Thanet District Council Stage 2 Design Options Response
Wednesday 10th June 2020

Notwithstanding any views on the future of the Airport site, Thanet District Council welcomes the opportunity to provide comments on the developing design options for departures from and arrivals to runway 28 and runway 10 at Manston Airport. These comments are based on the revised Appendix A submitted to the Council on Tuesday 12th May 2020, specifically the figures in Annexes A1-A4.

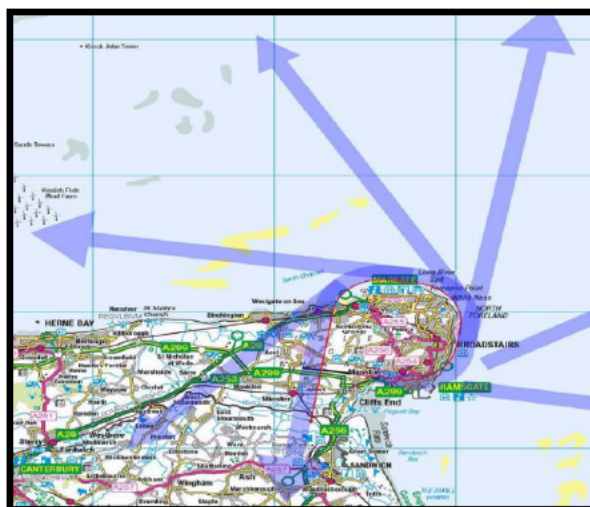
On this basis, the following design envelopes for departures **should not be used**:

- Figure 1 Runway 28 Left-Hand Departures travelling in the northerly direction and north-easterly direction should not be used.

- Figure 2 Runway 28 Right-Hand Departures travelling in the easterly direction, south-easterly direction and southerly direction should not be used (shown below).

- Figure 3 - Runway 28 Departures ANSP Constraints - No routes shown on plan.
- Figure 4 - Runway 10 Left-Hand Departures - All routes that travel around the Thanet Coast should not be used (shown below).

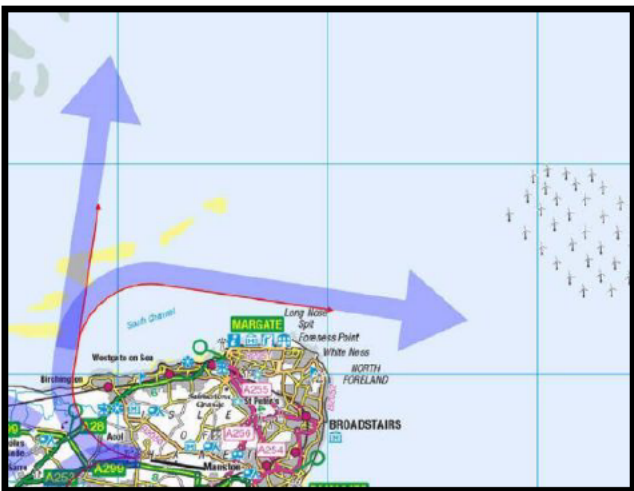
- Figure 5 - Runway 10 Right-Hand Departures travelling in the northerly direction and north-westerly direction should not be used (shown below on following page).

- Figure 6 – Runway 10 Departures (ANSP Constraints) travelling in the northerly direction should not be used (shown below).
